# UNITED STATES PATENT AND TRADEMARK OFFICE

APPLICATION NO.	FILING DATE	FIRST NAMED INVENTOR	ATTORNEY DOCKET NO.	CONFIRMATION NO.
10/766,136	01/27/2004	Walter J. Leclair	WLD-002	1966

<b>Office Action Summary</b>	<b>Application No.</b> 10/766,136	<b>Applicant(s)</b> LECLAIR, WALTER J.	
	<b>Examiner</b> Mary Hoffman	<b>Art Unit</b> 3733

## **DETAILED ACTION**

Drewry et al. (U.S. Patent No. 6,436,099)

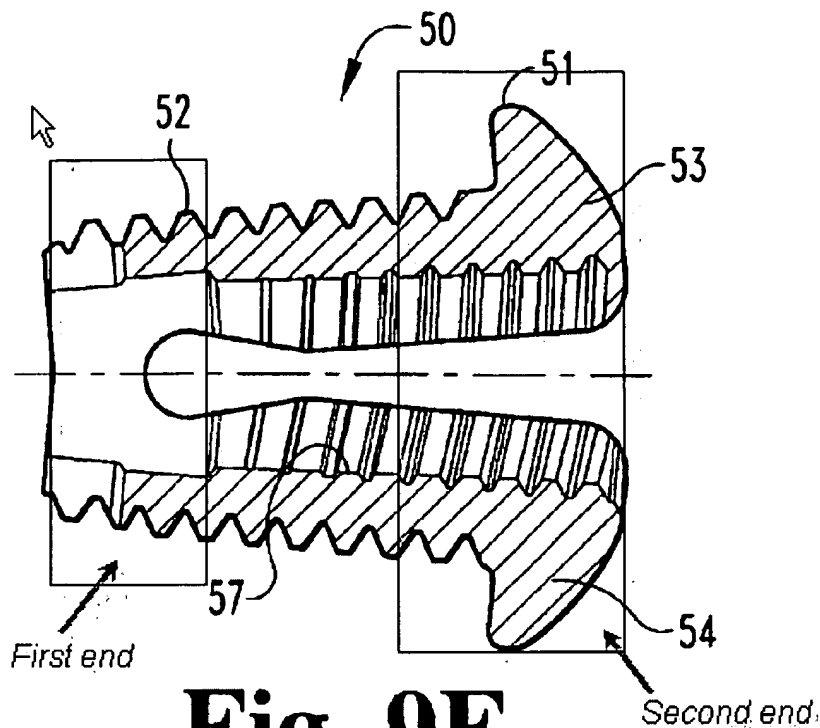
Applicant's arguments that the Drewry reference does not disclose "a screw thread extending from the second end...slots longitudinally formed in the shaft from the second end and creating a plurality of furcated branches", the examiner disagrees. After consultation with S.P.E. Examiner Robert, it was determined that the limitation "extending from the second end" is not specific enough to distinguish the invention of the application from the Drewry et al. reference. See the marked-up figure (next page) to illustrate this point.

A suggestion to aid in overcoming the Drewry et al. reference is to specify that there is an enlarged screw head is at the first end and the slots are located at the second end.
